Reply to Office Action of April 25, 2003

ANNOTATED SHEET SHOWING CHANGES:

PATENT
U.S. Ser. No. 09/803,350

Figure 2

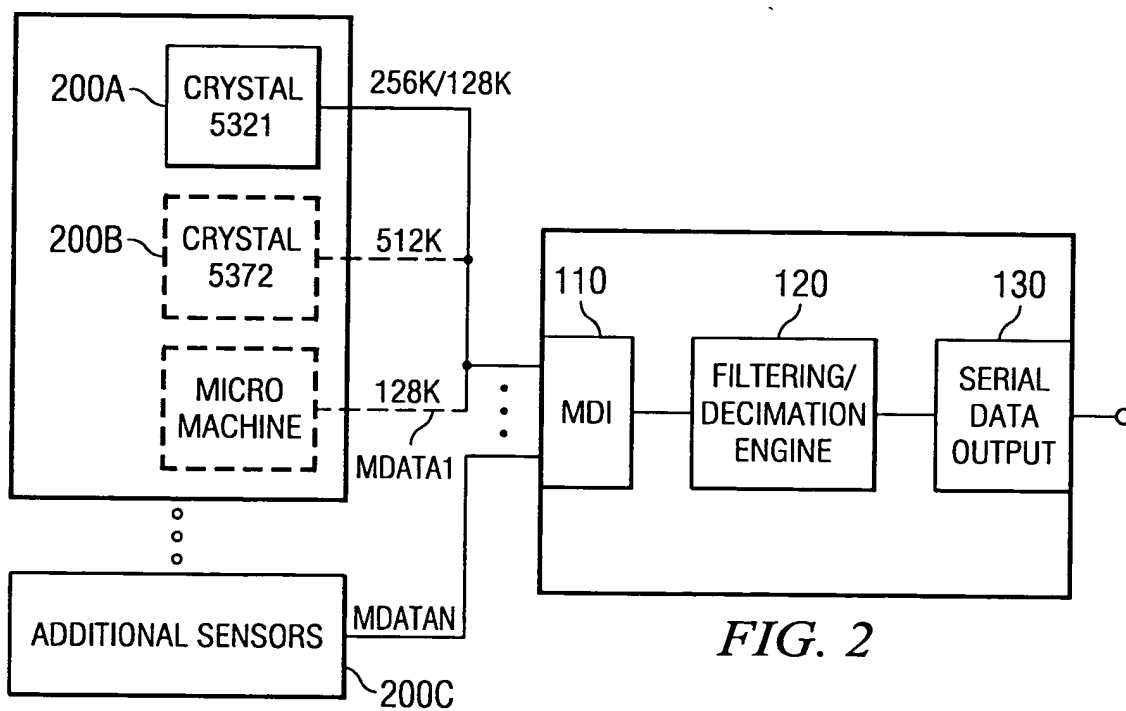
The drawings stand objected to under 37 C.F.R. 1.83(a) on the grounds that FIGURES 1-26 generally lack formality and particularly that FIGURES 2-4 and 31 contain unlabeled blocks that should be labeled according to their functions. All drawings currently being amended are shown with deletions struckthrough and additions indicated in red on the sheets attached for the convenience of the Examiner. Attached are replacement sheets that include the proposed changes.
